ADDENDUM NO. 2

BID NO. 2838

**CLOVIS EAST HIGH SCHOOL CTE FARM AND FOOD PRODUCT FACILITY
CLOVIS UNIFIED SCHOOL DISTRICT
CLOVIS, CALIFORNIA**

G.A. PROJECT NO. 1739

DETAILS
S6.2

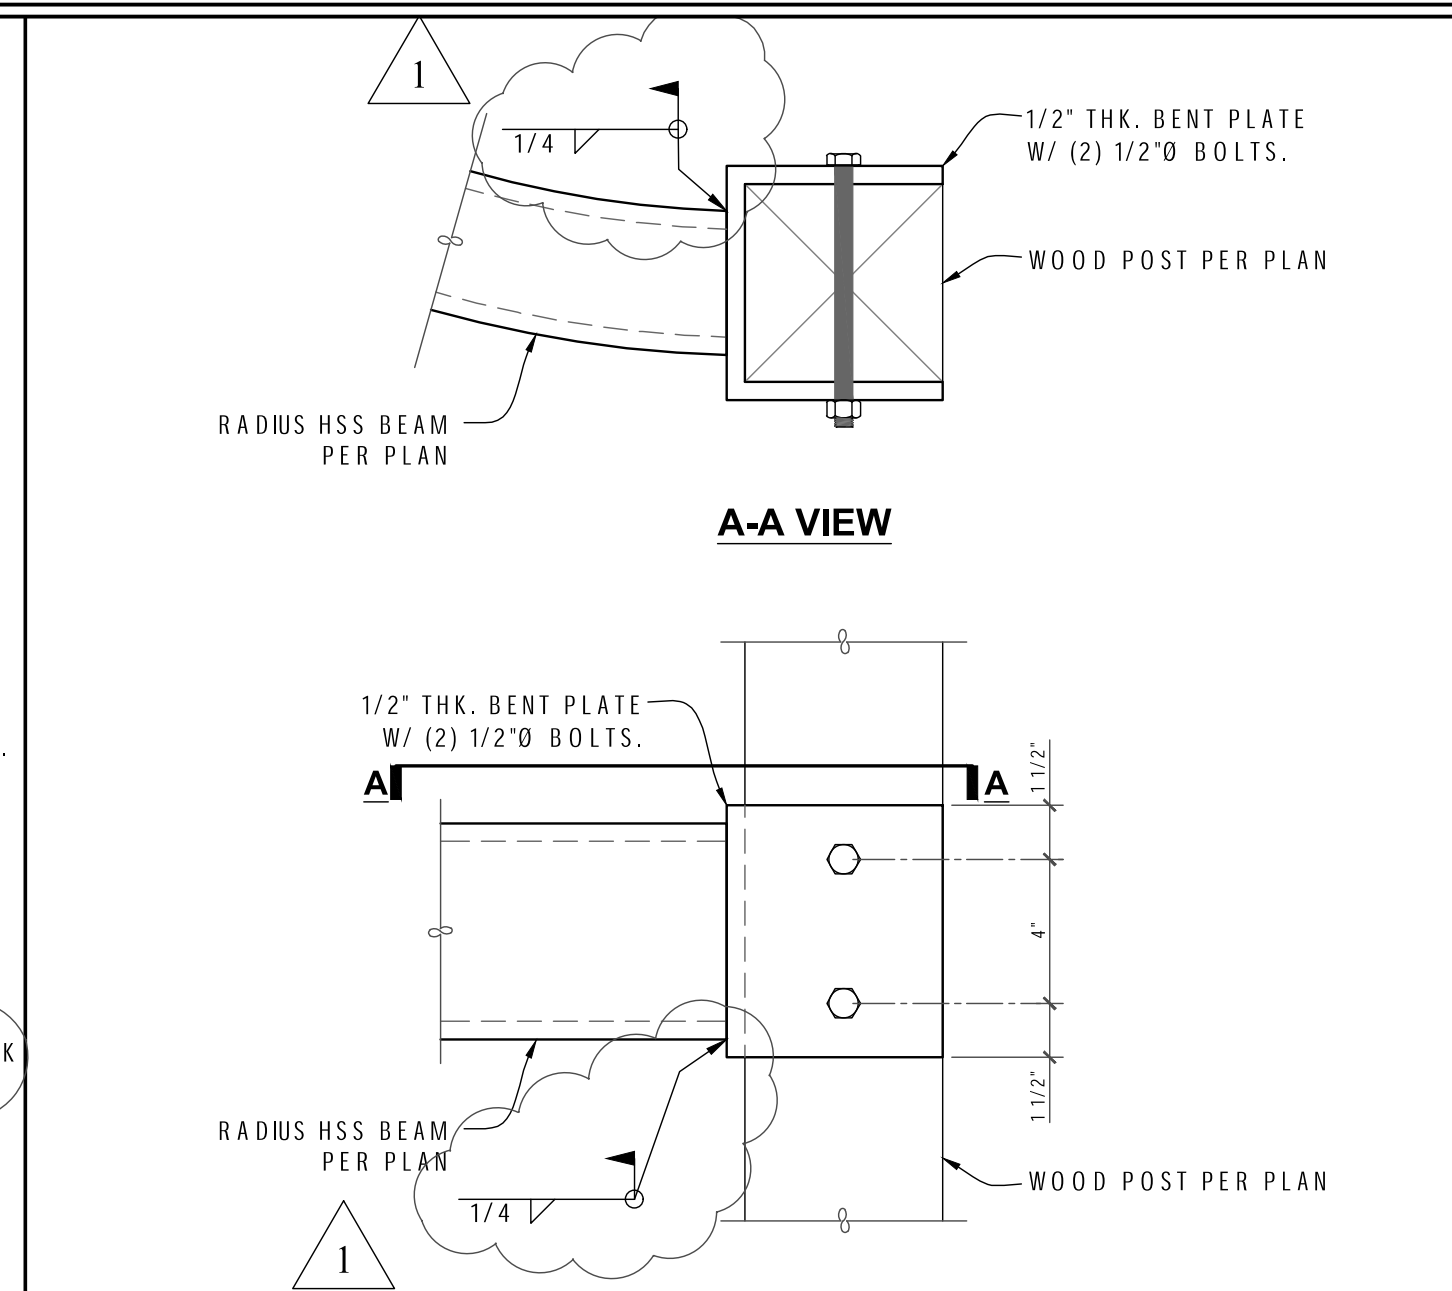
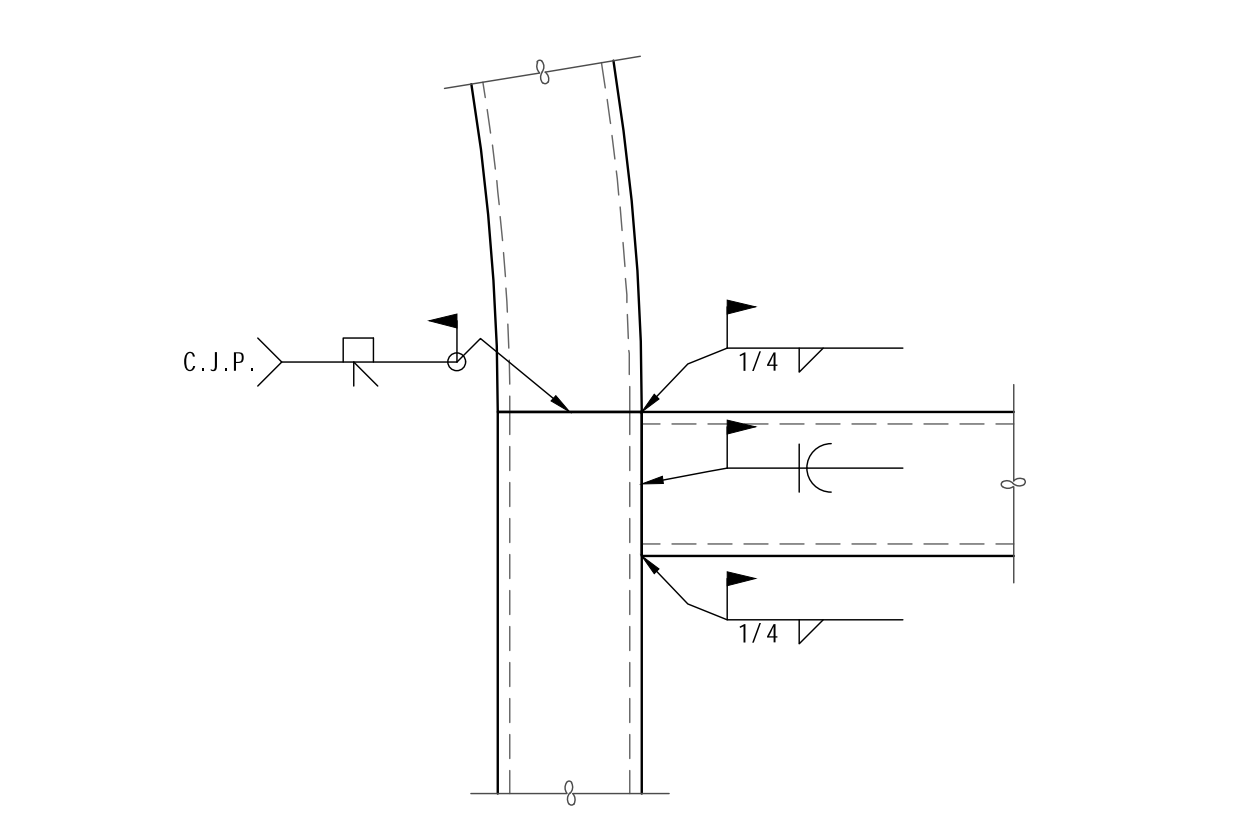
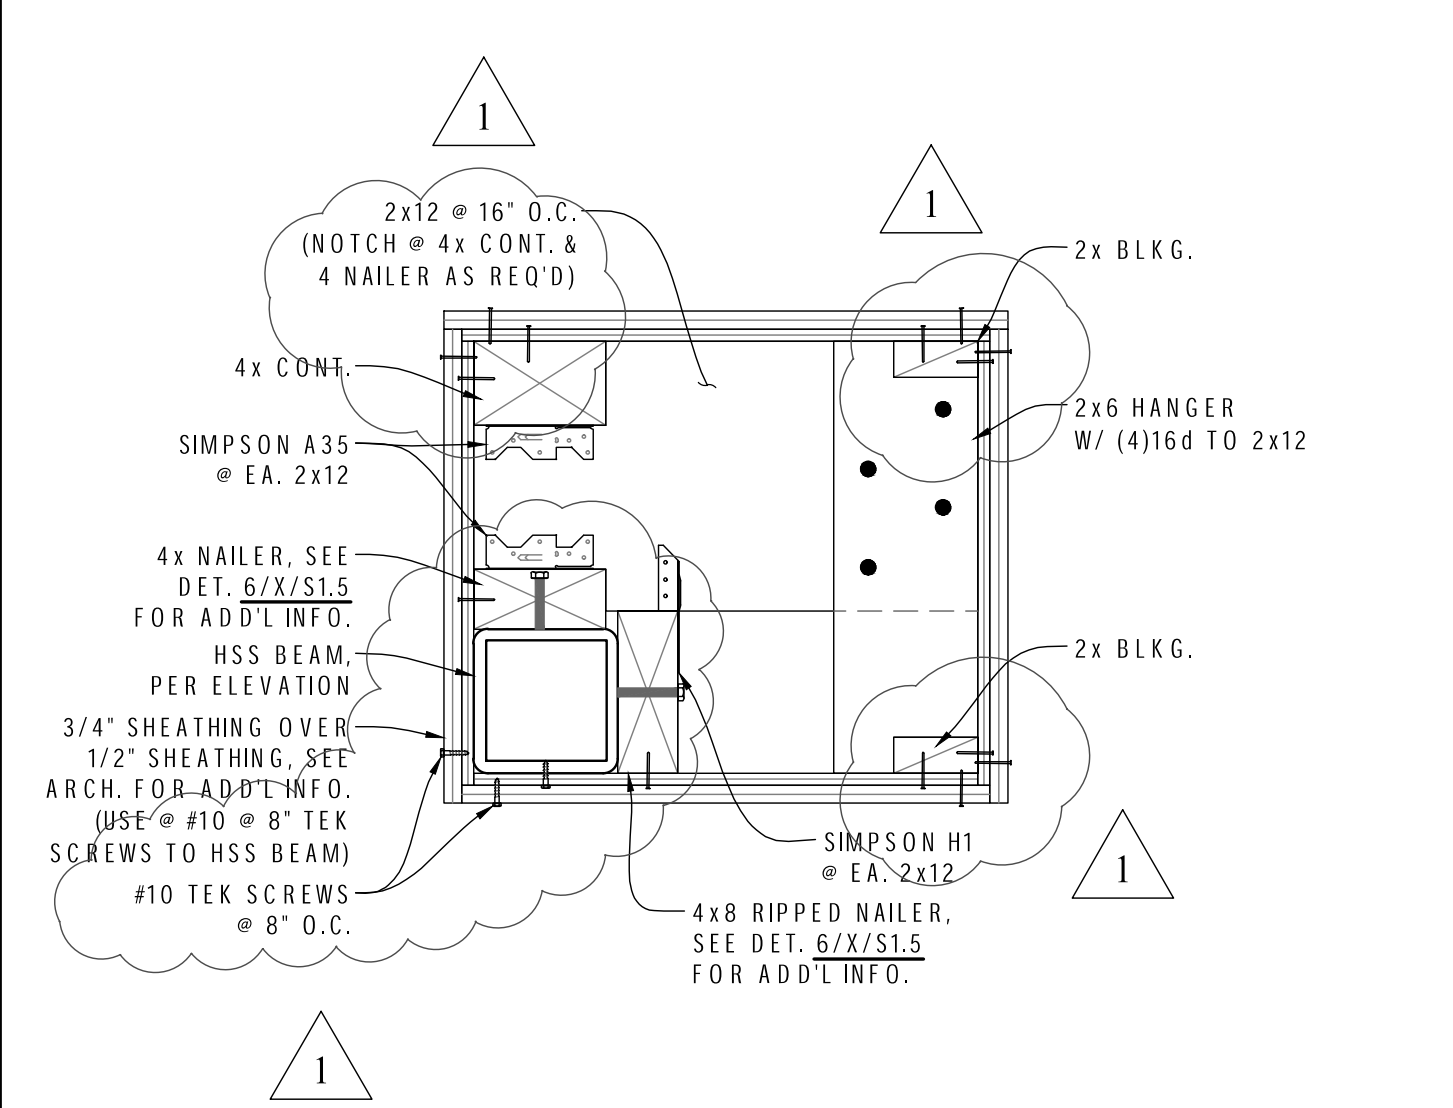
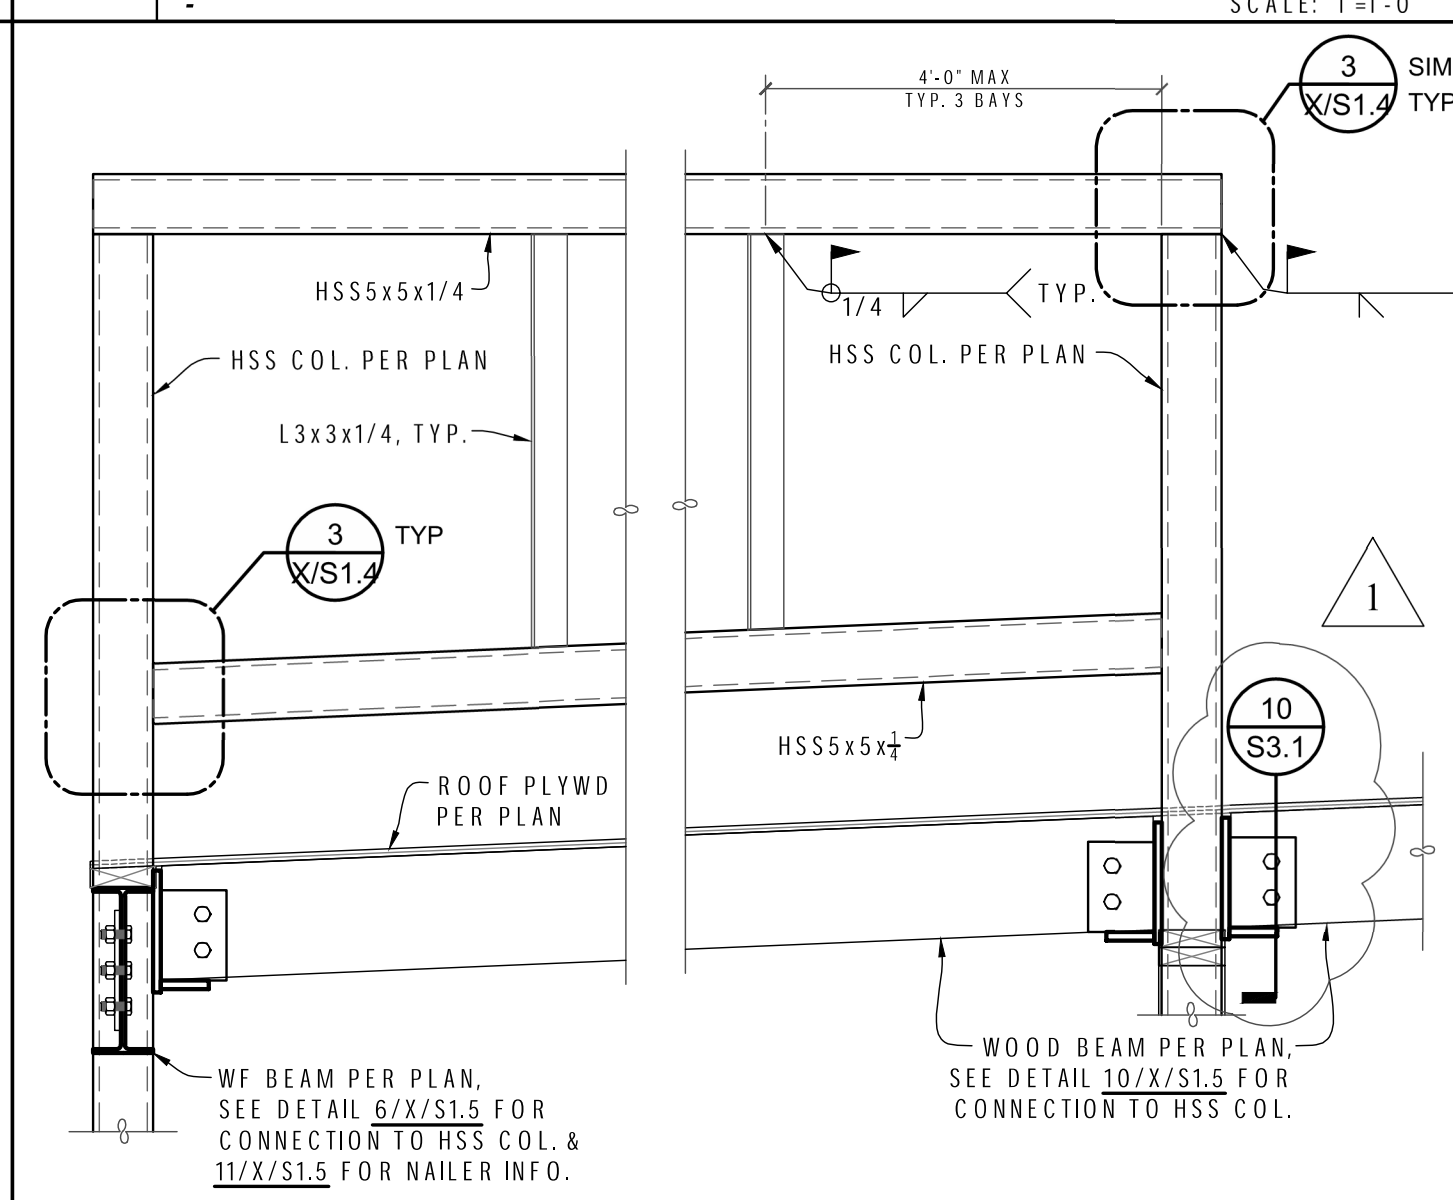
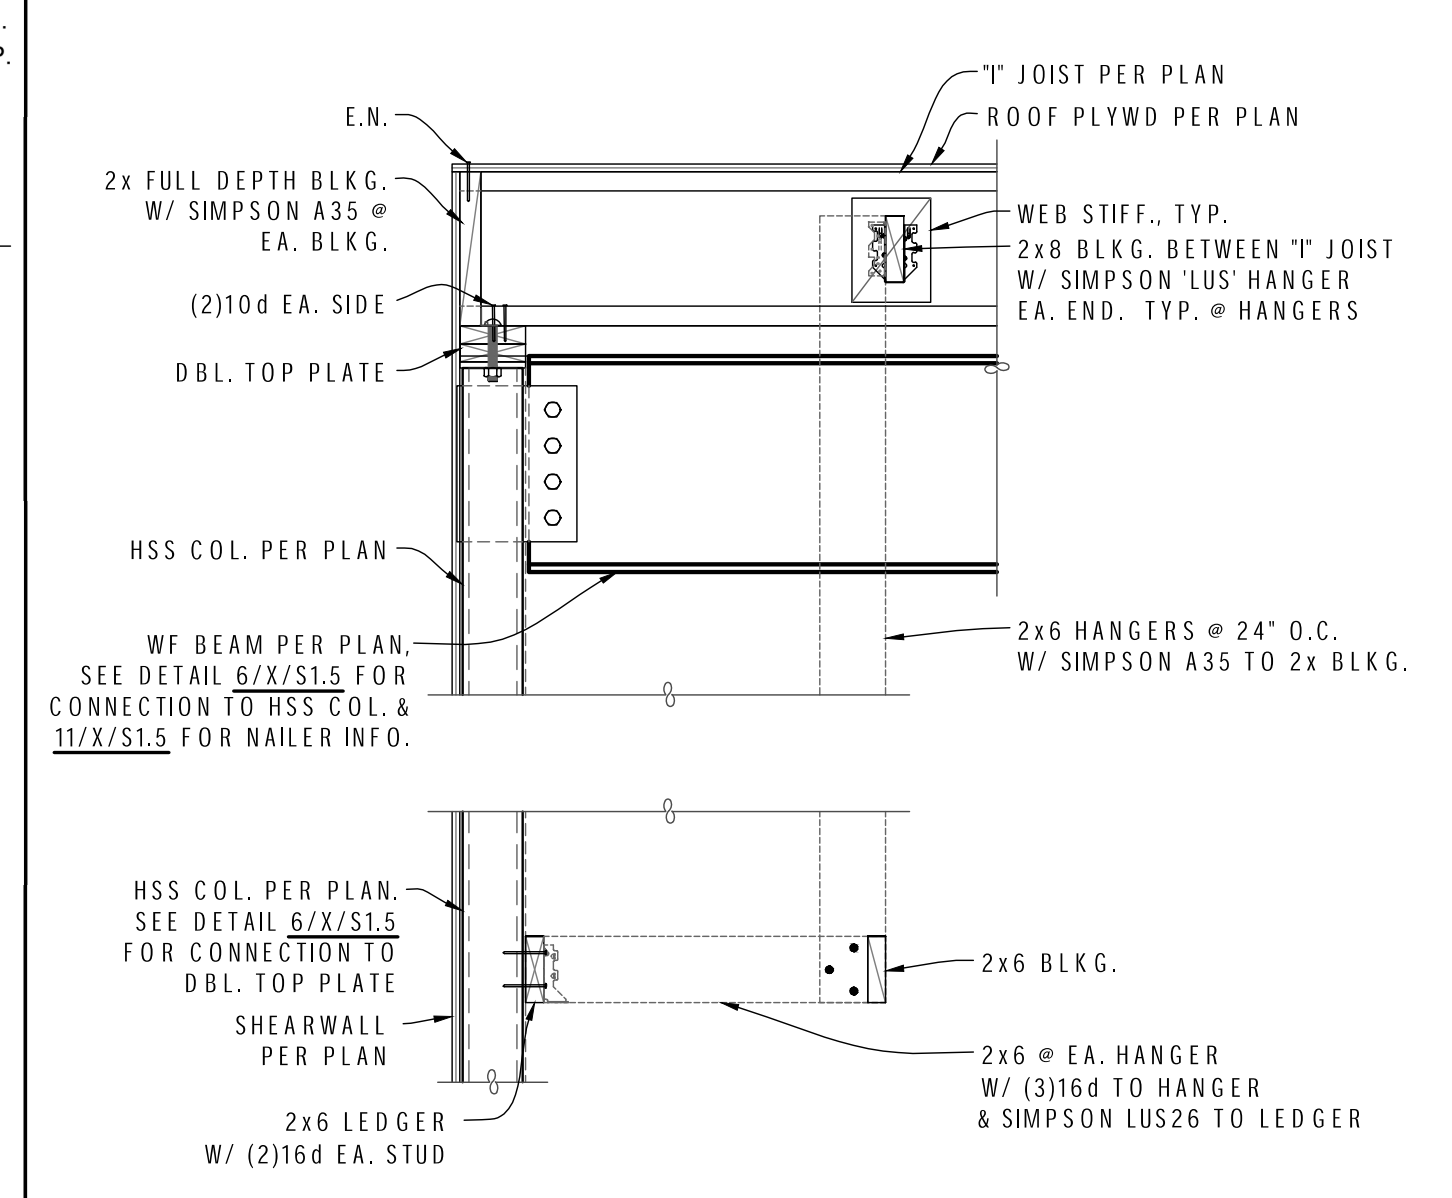
S6.2:

- 1.) Clarified weld call outs on detail 1.
- 2.) Revised and clarified soffit extent and WF beam detail Information on detail 3 and detail 4.
- 3.) Provided detail call out on detail 5.
- 4.) Revised detail 7.
- 5.) Clarified nailing on detail 8.
